**ATTACHMENT DR 15-S
REPORT OF WASTE DISCHARGE
AMENDMENT APPLICATION**

REPORT OF WASTE DISCHARGE AMENDMENT

Proposed Evaporation Ponds
Blythe Solar Power Project
Riverside County, California

Prepared by:
AECOM
Camarillo, CA
60280294
June 2013

Figure 1 BSPP Project Features

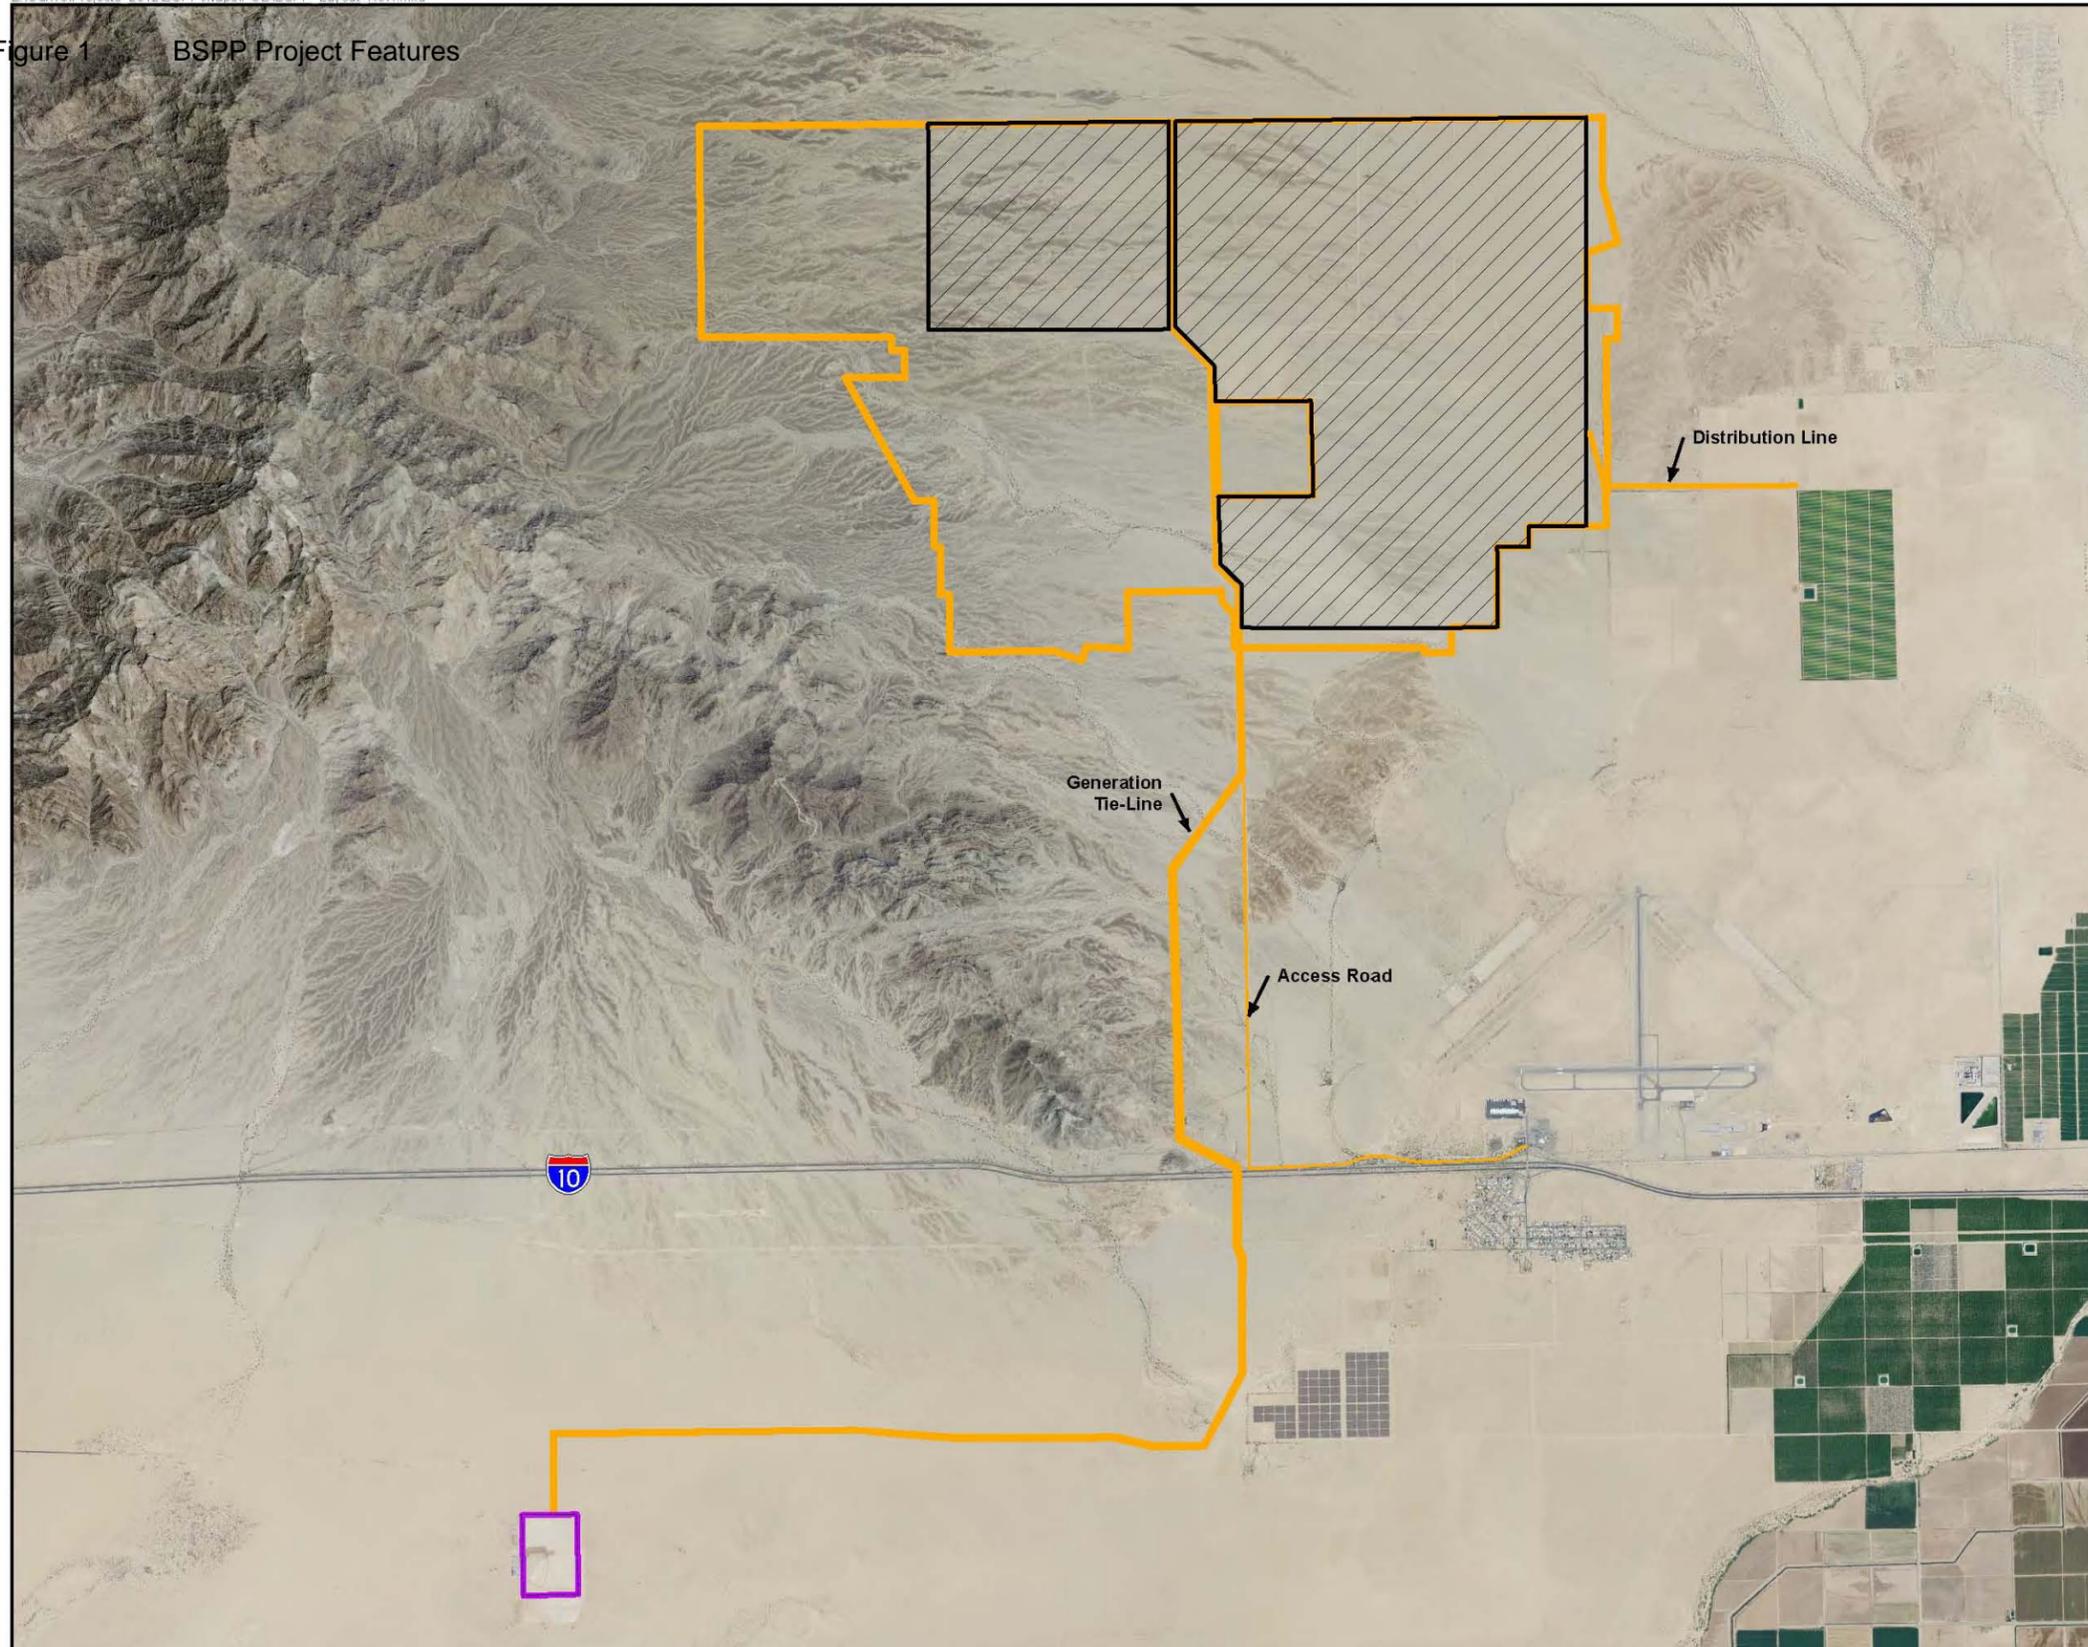
-  Approved Solar Thermal Project Boundary/Features
-  Reduced PV Solar Plant Site, 4,138 acres (Reduced from 6,831 acres)
-  SCE Colorado River Substation

Figure 2

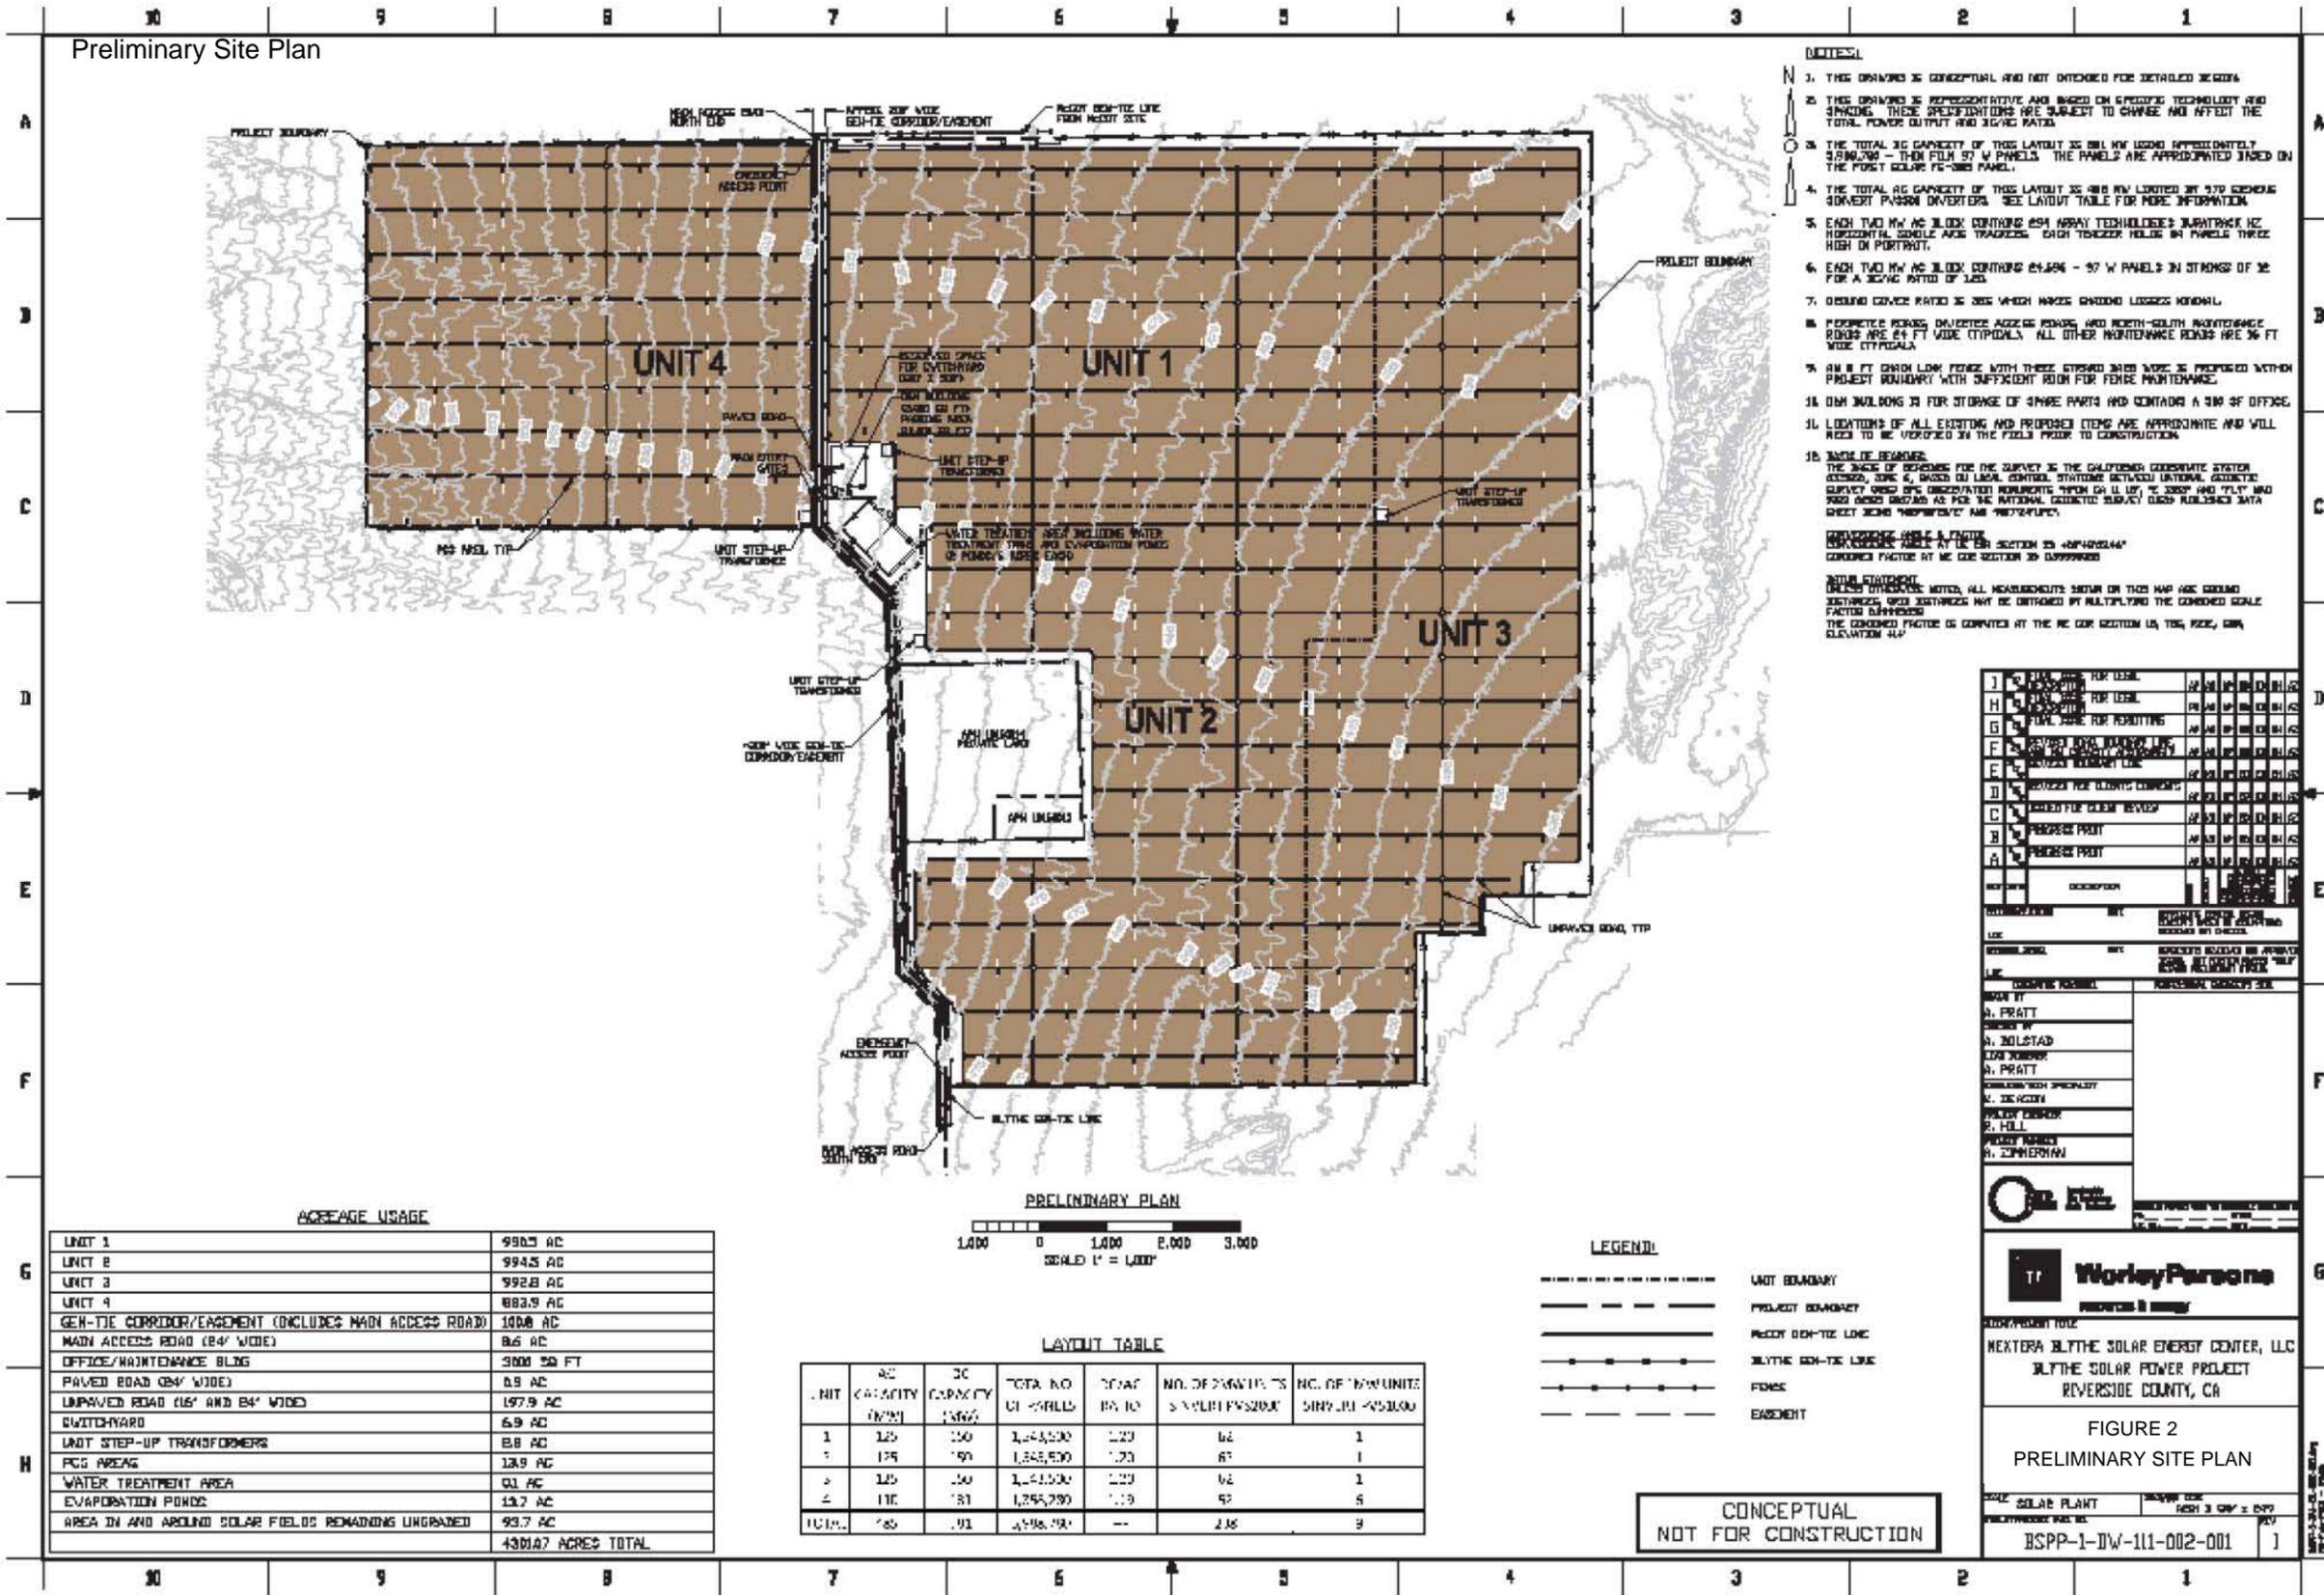
2. These WDRs regulate the Facility's ~~eight~~ **two** evaporation ponds and ~~two~~ LTUs. The evaporation ponds are designated as Class II Surface Impoundments Waste Management Units (WMU) and must meet the requirements of the California Code of Regulations (CCRs), Title 27, CCR §20200 et seq. The boundaries of the Blythe Solar Power Project are shown on (**Figure 2**), as incorporated herein and made a part of these WDRs.
